Determination 2020/033

The refusal to issue a code compliance certificate for historical building work to construct an outbuilding at 2/820 West Coast Road, West Melton

Figure 2: The original outbuilding

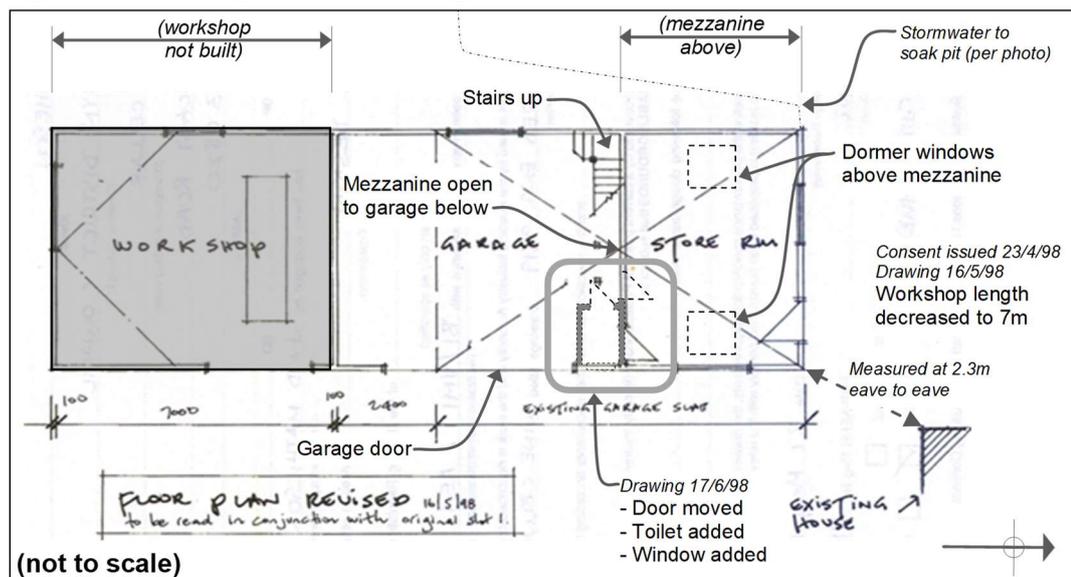
4.2.4 The authority added that other changes from the original consent drawing remained unresolved, such as changes to dormer window wall claddings and the omission of the workshop¹⁰. I have commented on the omission of a 'wine cellar' in paragraph 1.7.2.

- 5.2.2 The expert noted the following significant changes from the original consent drawings that were carried without a building consent¹³ (refer paragraph 2.2, Figure 2, and paragraph 2.3, Figure 3):

- the south workshop was not constructed
 - 4.8m wide east garage door replaced with a 3.2m wide ranchslider (Area B5)
 - a third dormer window was added to the west side of the south bedroom (Area D3)

Figure 3: The current building

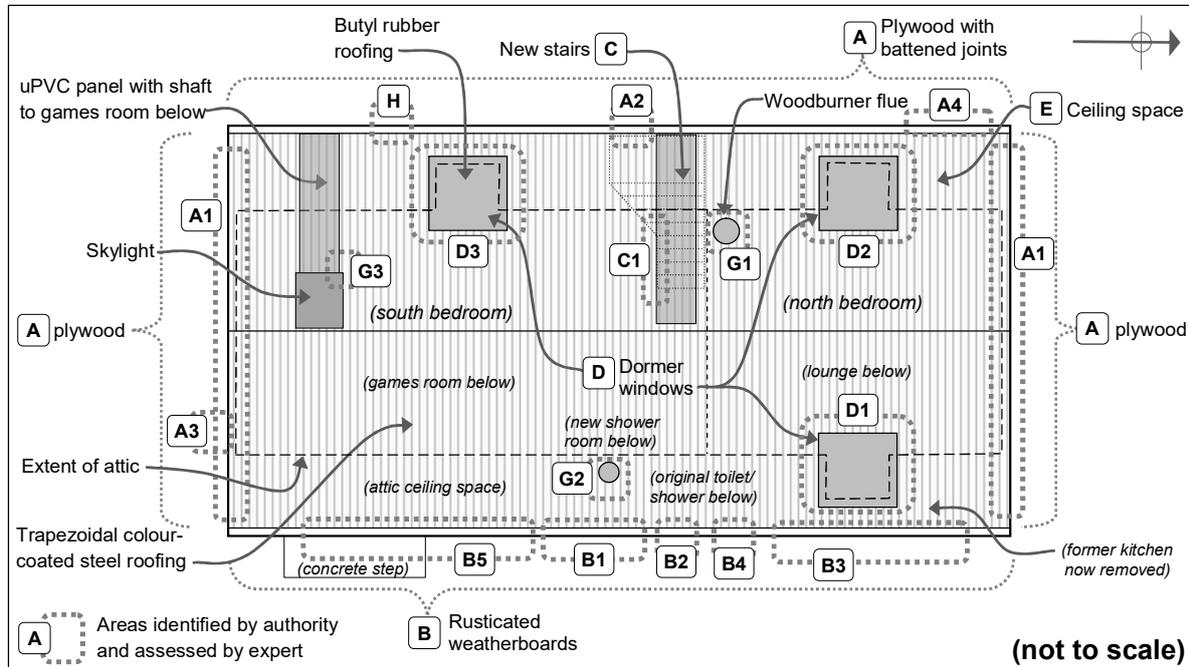
- plumbing, structural fixings and insulation incomplete at 1999 pre-line inspection, with outstanding work not re-inspected
- unsealed cladding penetrations (Areas A2, B1, B2, B4, G1, G2, G3)
- waste pipes not sealed to gully trap (Area B3, B4)
- no vent to toilet (Area B2)
- downpipes discharge onto ground
- unsealed internal wet areas
- changes from original building consent:
 - change of use from an “outbuilding” to “sleeping accommodation”⁶
 - location changes to windows and doors
 - gas califont with uninsulated pipework
 - addition of kitchen area
 - addition of showers
 - solid fuel heater added.

3.6.3 In regard to the building exterior, the surveyor noted (in summary, with relevant Figure 3 areas noted in brackets):

- concrete floor slab poured over original garage foundations with no protection at the junction and a bottom flashing is needed below wall claddings
- the lack of an appropriate outfall for stormwater discharging from downpipes

- the lack of ground and paving clearances below wall claddings
- for the plywood cladding (Areas A):
 - lack of battens to unflashed vertical joints
 - insufficient overlap to joints in horizontal Z flashing (Areas A1)

- various holes (Area A2) and unsealed penetrations through the cladding
- for the weatherboard cladding
 - unflashed butt joints in weatherboards (Area B1)

- unsealed jambs to ranchsliders and shower room joinery (Areas B1, B5)
 - unsealed pipe penetrations (Areas B2, B3)
- at the east gully traps
 - lack of haunching to gully traps (Areas B1, B4):

- waste pipes not sealed to gully traps (Areas B1, B4):
 - gaps at waste pipe/foundation junction (Area B4)
- for the dormer windows
 - lack of wall cladding/roofing clearances (Areas D1, D2, D3)

- unflashed weatherboard/plywood corner junctions (Area D1)
 - unflashed corners to plywood claddings (Area D2, D3)
- for penetrations through roofing

- unflushed shower vent (Area G2)
 - hole at the lower end of the skylight (Area G3).
- 3.6.4 In regard to the building interior, the surveyor noted (in summary, with relevant Figure 3 areas noted in brackets):
- for the original staircase (Area C):
 - balustrade wires are too flexible and widely spaced
 - balustrade too low at 800mm
 - gap between stair treads is too high
 - irregular height of the bottom step
 - the height of barrier to south bedroom is too low (Area C1)
 - the games room ceiling is unlined
 - thermal imaging showed evidence of insulation in walls and ceilings.
- 3.6.5 The building surveyor concluded once all the items identified in the report were rectified a certificate of acceptance could be sought.

- dormer walls clad in plywood and weatherboards instead of butyl rubber
 - bathroom with window added adjacent to the east toilet (Area B1)
 - new staircase added, replacing the original (Area C).

6.4.5 The expert's investigations included removing linings below one dormer window (Area D2), which revealed current leaks and evidence of advanced decay in the dormer framing. This indicated the dormer had been leaking for an extended period of time. Signs of moisture entry and timber staining were also observed in areas associated with the other north dormer window (Area D1).

6.4.6 I am not satisfied the two northern dormer windows have been weathertight and durable for a considerable time, based on: the expert's investigations; the changes in wall cladding from the consent drawing; the defects identified by the previous owner's building surveyor in 2017; and the similar construction details assumed for the other two dormers. I therefore conclude the two original dormer windows do not comply with Clause E2.

6.4.7 The two original dormer windows are now some 20 years old. Further investigation and remedial work will be required to ensure that the dormers are made weathertight so as to protect the underlying timber framing from the penetration of water which could cause dampness or damage to building elements, as is required to meet the minimum durability requirement of 50 years.

6.5.2 I conclude that further investigation and/or remedial work is necessary to the building work from the original building consent, in respect of the following areas:

- Clauses B1 and B2:
 - some inadequately nailed joist hangers
 - damaged and potentially damaged framing associated with dormer windows (Areas D1 and D3)
- Clauses E2 and B2:
 - weathertightness and durability of dormer windows (Areas D1, D2 and D3)
- Clause E3
 - lack of sealant to the handbasin/splashback junction (toilet area)
- Clauses F4:
 - lack of compliant barrier to stair landing window
- Clause H1:
 - though insulation has been installed, there is insufficient information with regard to the performance of the insulation installed in the roof to establish compliance of the whole of the building envelope.
